DEPARTMENT/ INSTITUTION	BID NUMBER & PROJECT DESCRIPTION	CONTACT PERSON
DEPARTMENT OF TRANSPORT **PTB No. 27**	# ADDENDUM No.1 **SCMU10-26/27-0018: CONSTRUCTION OF GALI RIVER CROSSING ON DR08592** **REASONS FOR ADDENDUM** The reasons for this addendum is to respond to queries raised and to correct material errors identified in the BOQ after publication. This contract is re-measurable. 1. Item C3.2.5.1 – Prefabricated Portal Culverts > Delete and Replace with: a) **S 3000 D 3200 W 3640 C150 TT 130 – 290 units** – Main River crossing structure as per Drawing BMK-1784-GB-001 Rev 2. Note portals to be installed 100mm apart. Supply, lay and joint complete. b) **S 1500 D 1675 W 1860 C150 TT 130 – 50 units** – Retained for re-measurement / avoid Rates Only c) **S 1800 D 1675 W 1860 C150 TT 130 – 50 units** – Retained for re-measurement / avoid Rates Only 2. Omission of Gabions – New items included, revised BOQ pages attached. **THE CLOSING DATE IS EXTENDED** **FROM 02 NOVEMBER 2026 AT 11:00** **TO 09 NOVEMBER 2026 AT 11:00**	**TECHNICAL / PROJECT ENQUIRIES** Miss A Bobo Cell no: 0776069087 Email address: Aviwe.Bobo@ectransport.gov.za Mr. ET Chiro Cell no: 0632761428 Email address: edward@

Reference: Bill of Quantities – Item C3.2.5.1 – Prefabricated Portal Culverts (Existing Document – Before Correction)

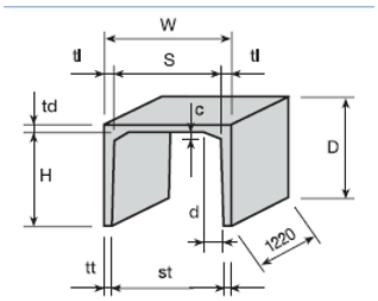
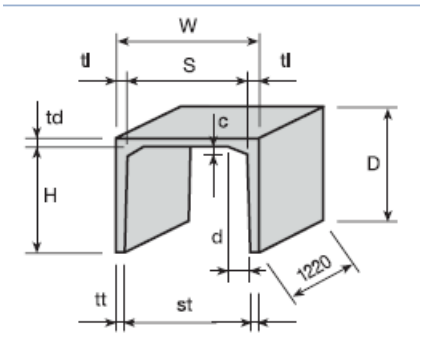
This version contained material errors and is hereby superseded in its entirety.

Delete and Replace with:

a) S3000 D 3200 W 3640 C150 TT 130 – **290 units** – Main river crossing structure as per Drawing BMK-1784-GB-001 Rev 2. Supply, lay and joint complete.

b) S1500 D 1675 W 1860 C150 TT 130 – **50 units** – Retained for re-measurement / to avoid Rates Only.
c) S1800 D 1675 W 1860 C150 TT 130 – **50 units** – Retained for re-measurement / to avoid Rates Only.
